**County of Albemarle
Department of Community Development**

Memorandum

To: Cameron Langille, Community Development Planning and Zoning Review
From: J. E. Anderson, PE, CE-II, Community Development Engineering Review
Date: April 8, 2021
Subject: SE202100012 – Boys & Girls Club/Driver’s Ed – Critical Slopes Impact Review

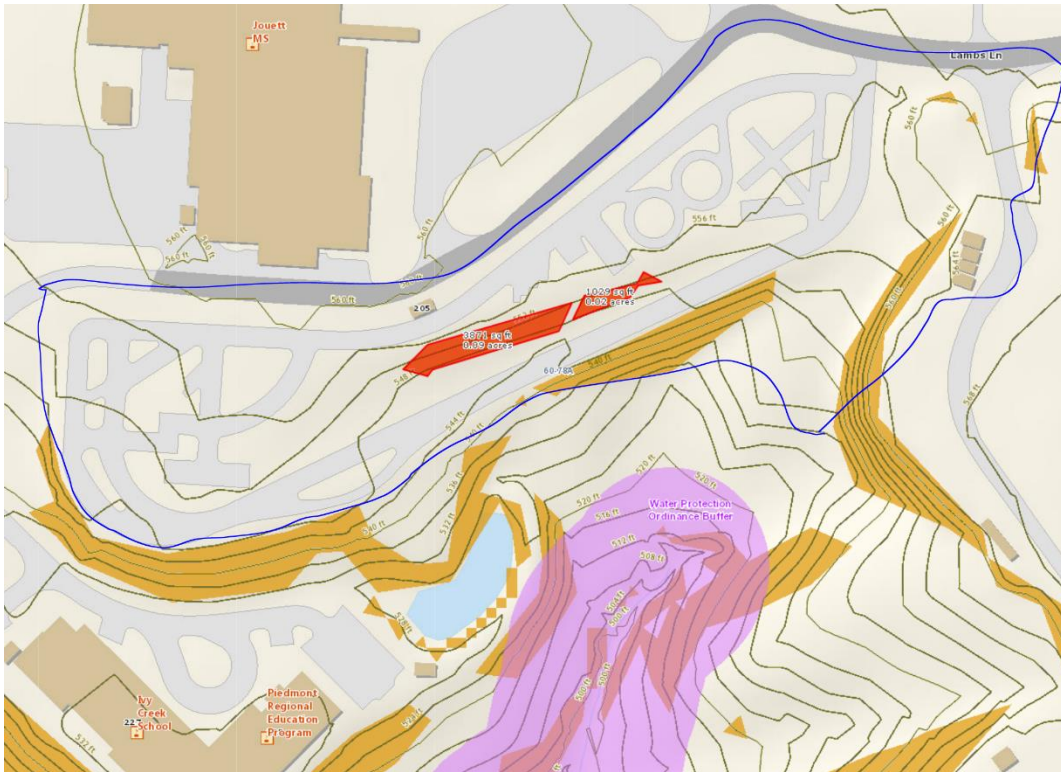
Purple area in image above is WPO (stream) buffer. Yellow-tan areas are critical slopes.

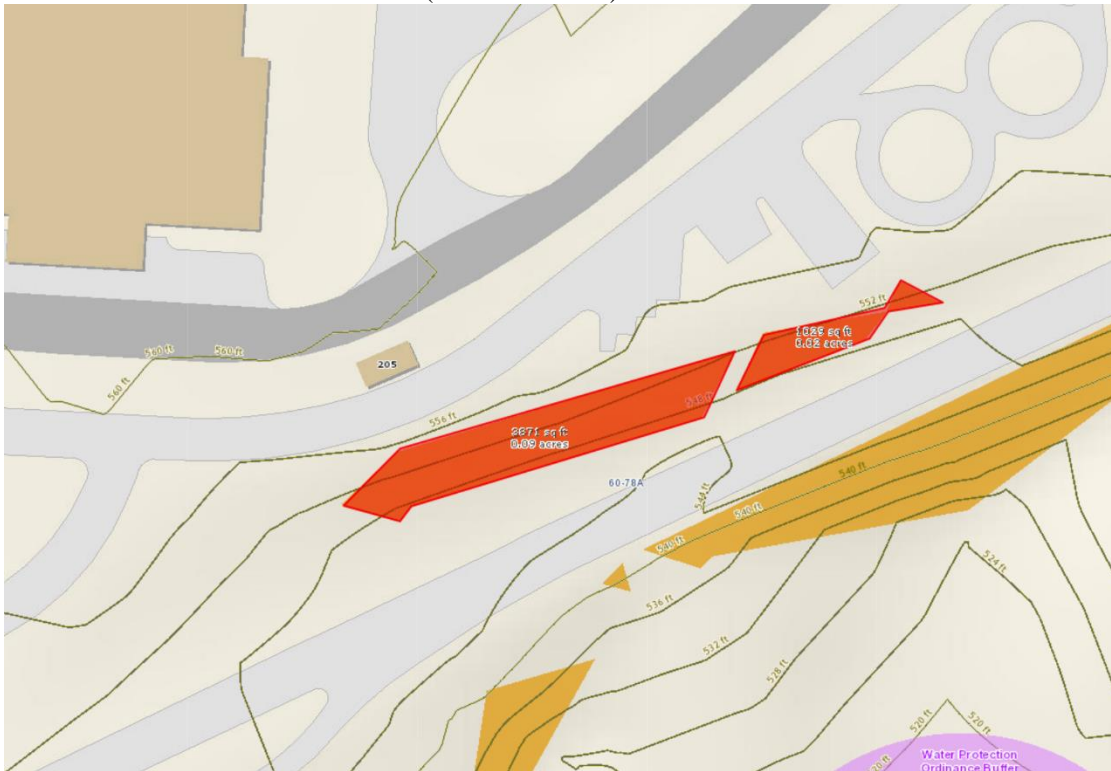
Approximate limits of project site shown by blue outline, above. ~0.11 Ac. critical slopes lie within paved circuit of the driver education course (red-shaded area).
